# Code of Good Manufacturing Practice

The following is a list of problems which have been observed at various trailer builders from time to time by BPW staff members. As they can all lead to future problems we have decided to issue the following advisory to prevent damage being caused to the BPW products during the manufacturing of the trailer.

TT10-0715 **1**

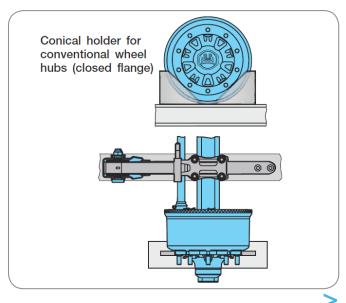
After the axles and suspensions have been mounted to the chassis on the assembly line, temporary wheels must be fitted on at least one of the axles. This is to ensure that the trailer does not rest on the brake drums on the production floor. The brake drums are not designed to carry the weight of any empty vehicle on the open side of the drum. The result of this practice is that the brake drum can develop internal cracking and failure of the brake drum can occur in operation, causing extensive damage. There have been incidences where the brake drums have burst and damaged the brake spider to the extent that the complete axle has had to be replaced. When these brake drums were sent for material testing no abnormalities in the material specification could be found. This leads BPW Axles to suspect mechanical damage to the drum resulting from mishandling, including those illustrated above.

- Another thing to be avoided is the practice of allowing the vehicle to slam down onto the brake drums when turning the vehicle over after welding on the suspension. This can also result in damage to the brake drums in the form of cracks.
- You must also avoid accidently dropping the axle onto the drums while moving it around.

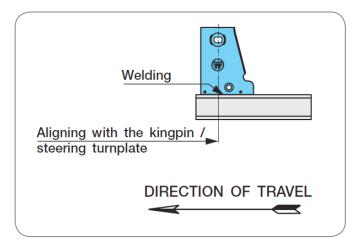
The airbag must be covered before painting to prevent damage to the rubber from the thinners in the paint. Often this is not done and the thinners will make the rubber bellow brittle, shortening the life of the airbag. Rather leave the airbag off until the vehicle has been completely painted.

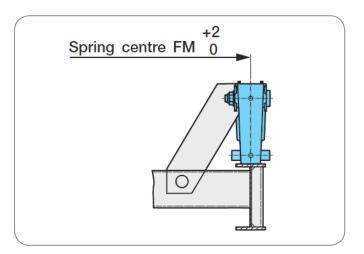
- The length of the spacer can be made so that when fitted the vehicle is already at the correct ride height as if the airbags were installed and inflated. With the suspension at the correct ride height the stress on the Steel-Rubber-Steel bush in the pivot eye of the trailing arm is kept within limits and it will last longer and not be subject to premature wear. Once the bush is damaged the pivot bolt will be permanently loose, even before the trailer enters service.
- If no spacers are fitted the entire weight of the vehicle can rest on the shock absorbers and through them onto the shock absorber mounting bolts. These bolts are not designed to carry this weight and can break off.
